SVS-05-13
5/8/2013

SUBJECT: ALL 4L-SERIES ENGINES ELIMINATION OF OIL PUMP O-RING

Case2:OIL PUMP is attached to FRONT PLATE

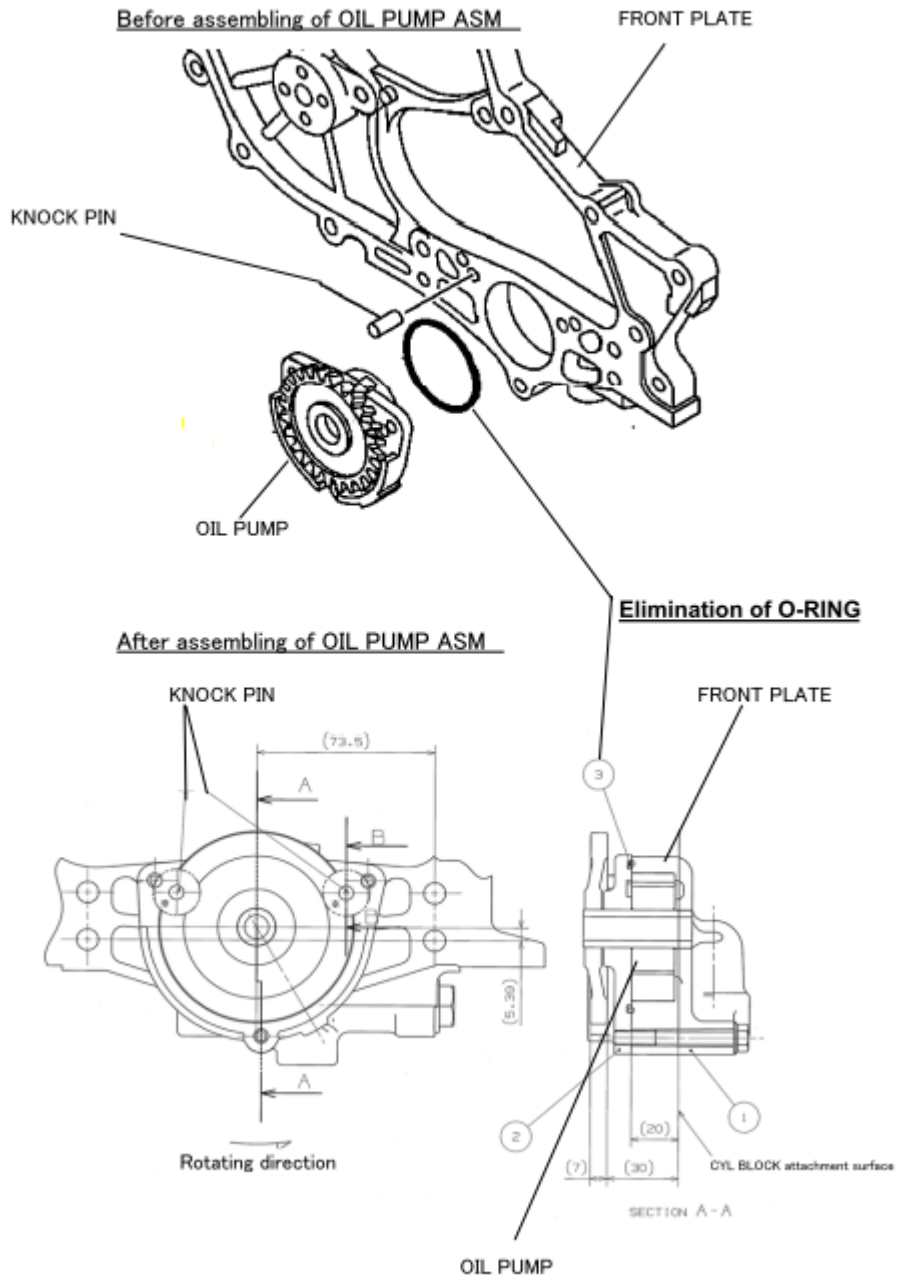
Isuzu Motors America, LLC PowerTrain Division (ISZAPT) has eliminated the oil pump O-ring gasket on all 4L-series engines due to parts communization (includes Tier 4 replacement engines). This is the O-ring fitted between the oil pump and oil pump body. Please refer to the pages below for details. This parts change will be implemented in production engines in June 2013.

Interchange Ability	Affected Parts	Current Parts	Q'ty	New Parts	Q'ty
	GASKET;OIL PUMP	897109 6790	1	(Elimination)	-
